V2500-A1/A5/D5 SERIES PROPULSION SYSTEMS SERVICE BULLETIN

This document transmits the Initial Issue of Service Bulletin V2500-ENG-75-0119.

AIR – ACTIVE CLEARANCE CONTROL – INTRODUCTION OF MOUNTING BUSHES WITH COUNTERBORE**1. Planning Information****A. Effectivity****(1) Airbus A319**

Active Clearance Control Actuator Linkages
V2500-A1 and V2500-A5 Engines
Figure 1 (Sheet 1 of 3)

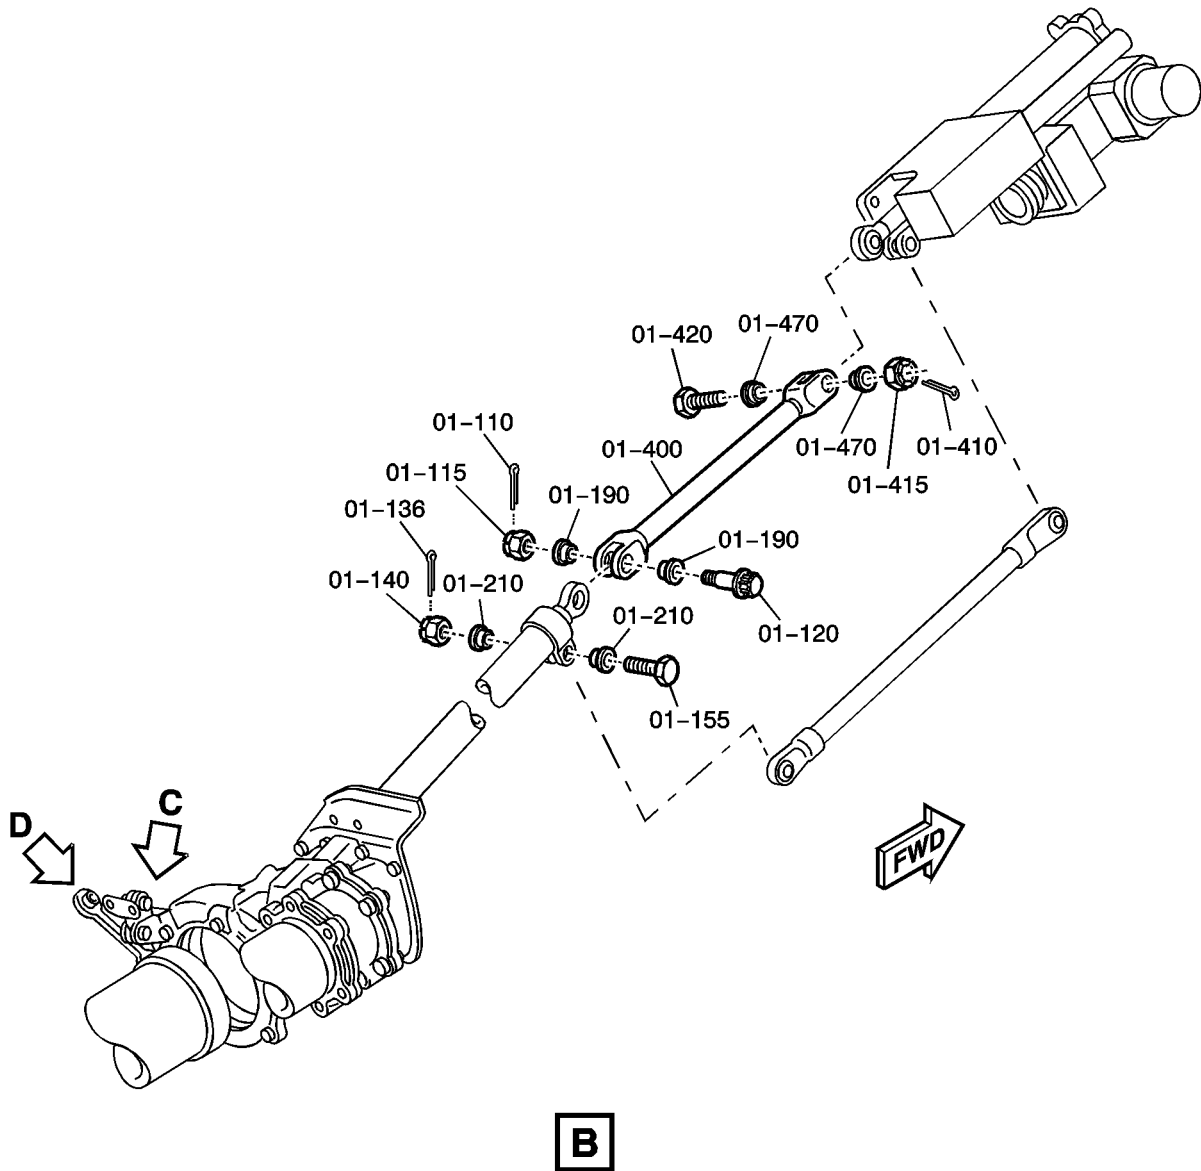
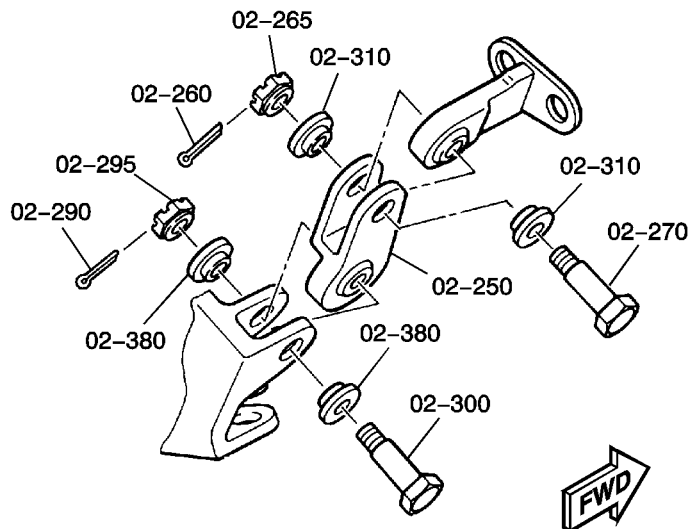
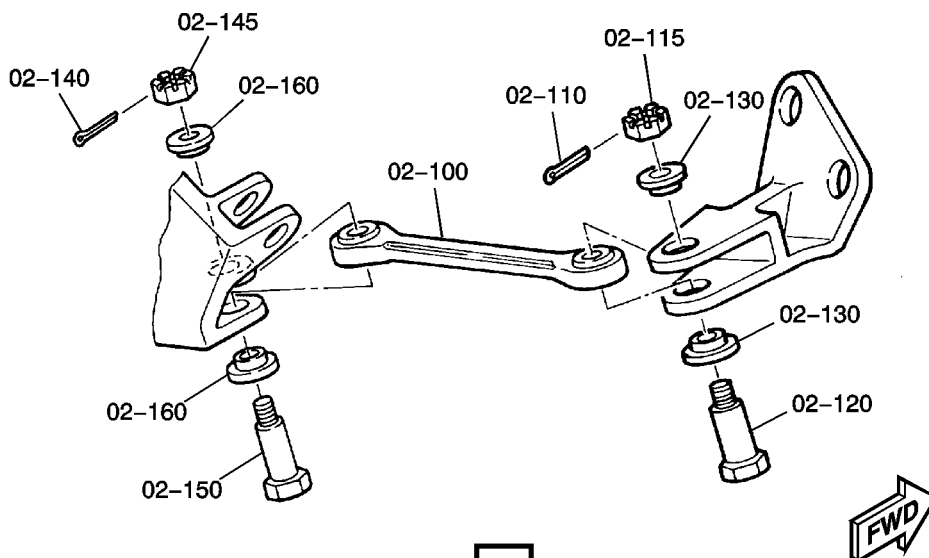
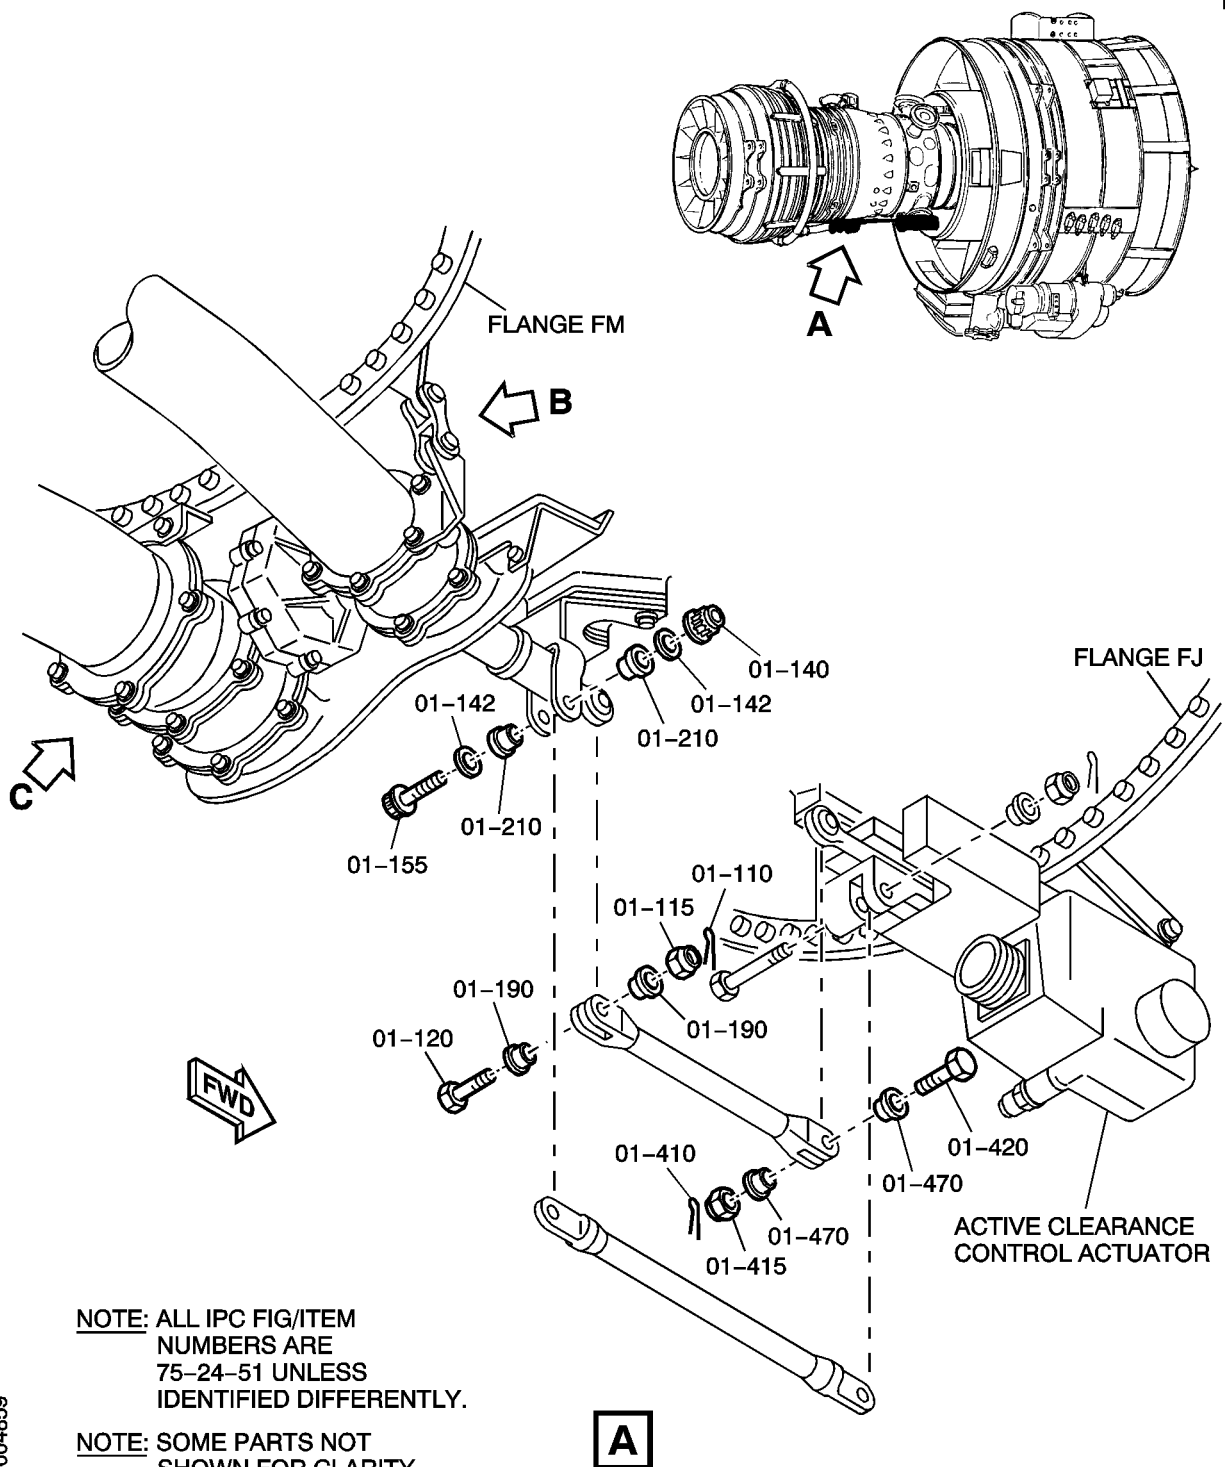
This Service Bulletin introduces a redesigned bush with a counterbore within the range of the cold working distortion area of the bolt.

- (a) For V2500-A1 and V2500-A5 engines only (Refer to Figure 1):

(a) For V2500-A1 and V2500-A5 engines only (Refer to Figure 1):

- (i) If scheduled, install the two new bushes (75-24-51, 02-310), P/N 6B1465.

Torque the nut (75-24-51, 02-265) to 32.5 to 42.5 lbf in. (3,67 to 4,8 Nm).

If scheduled, install the two new bushes (75-24-51, 01-210), P/N 6B1465.

Torque the nut (75-24-51, 01-140) to 32.5 to 42.5 lbf in. (3,67 to 4,8 Nm).

If scheduled, install the two new bushes (75-24-51, 01-190), P/N 6B1465.

Torque the nut (75-24-51, 01-115) to 22.5 to 30 lbf in. (2,54 to 3,39 Nm).

Active Clearance Control Actuator Linkages
V2500-D5 Engines
Figure 2 (Sheet 1 of 2)

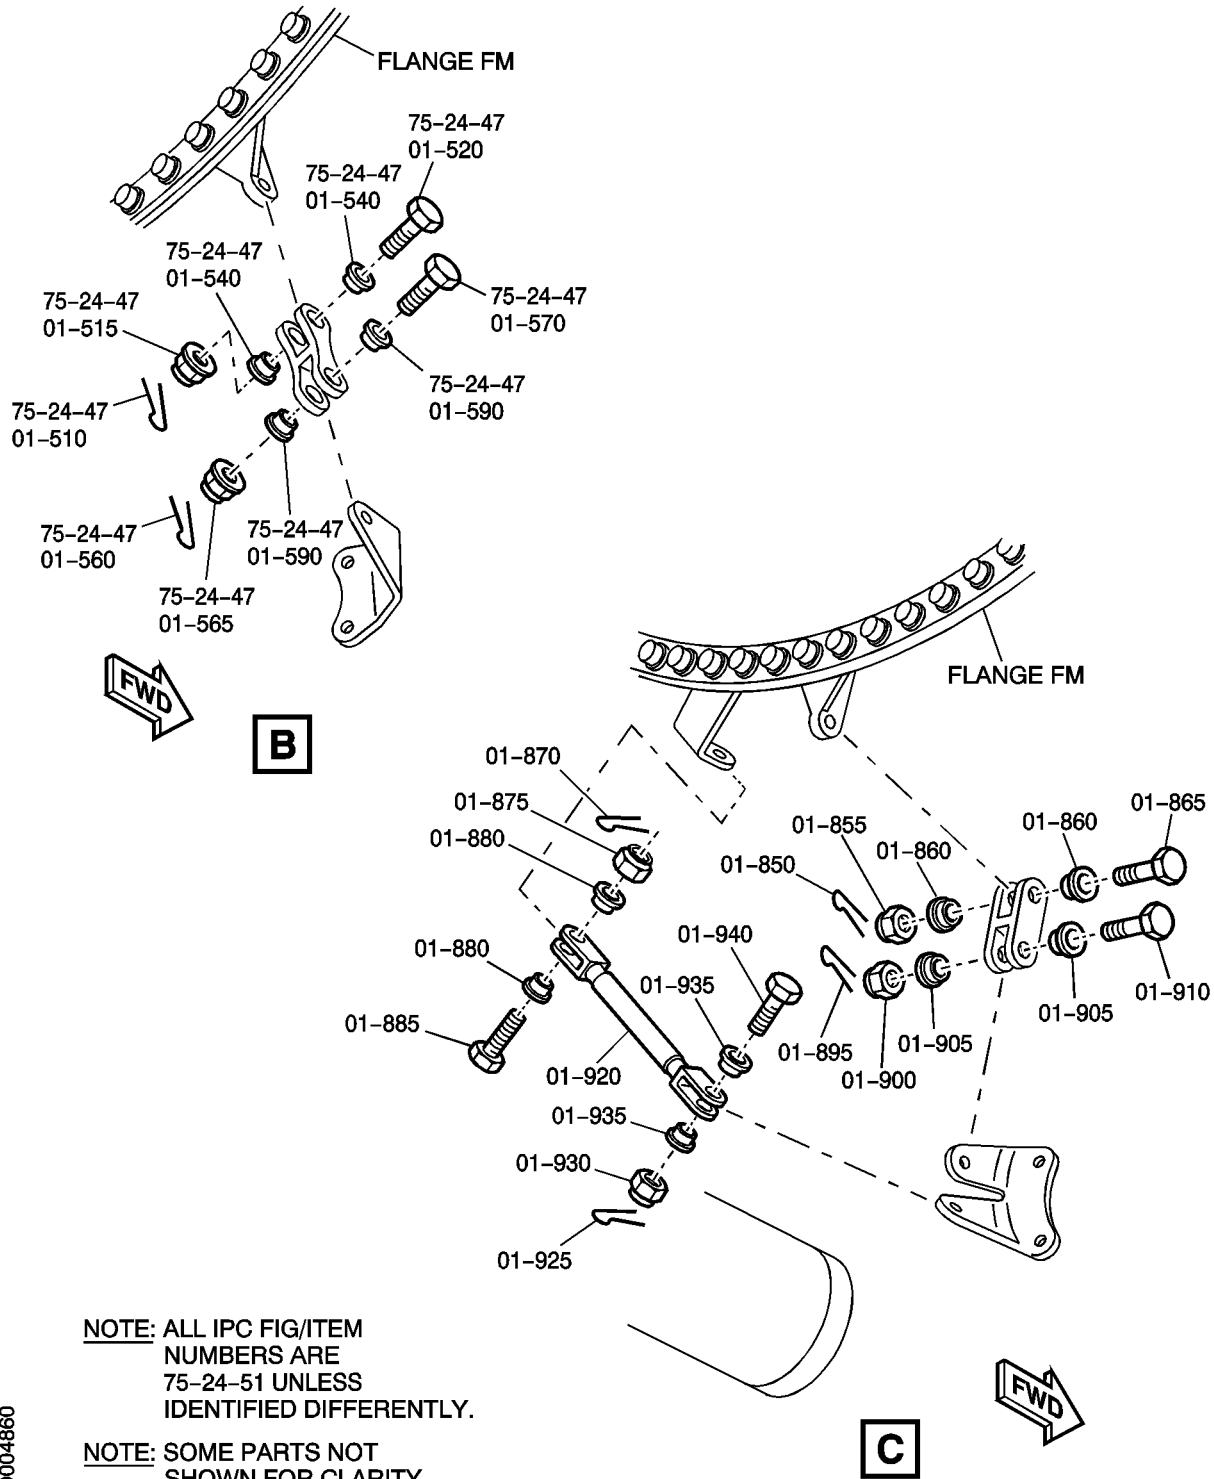
(c) For V2500-D5 engines only (Refer to Figure 2):

- (c) For V2500-D5 engines only (Refer to Figure 2):

If scheduled, install the two new bushes (75-24-51, 01-210), P/N 6B1465.

Torque the nut (75-24-51, 01-140) to 88.5 to 106 lbf in. (10 to 12 Nm).

- (i) If scheduled, install the two new bushes (75-24-51, 01-860), P/N 6B1465.

Torque the nut (75-24-51, 02-855) to 32.5 to 42.5 lbf in. (3,67 to 4,8 Nm).
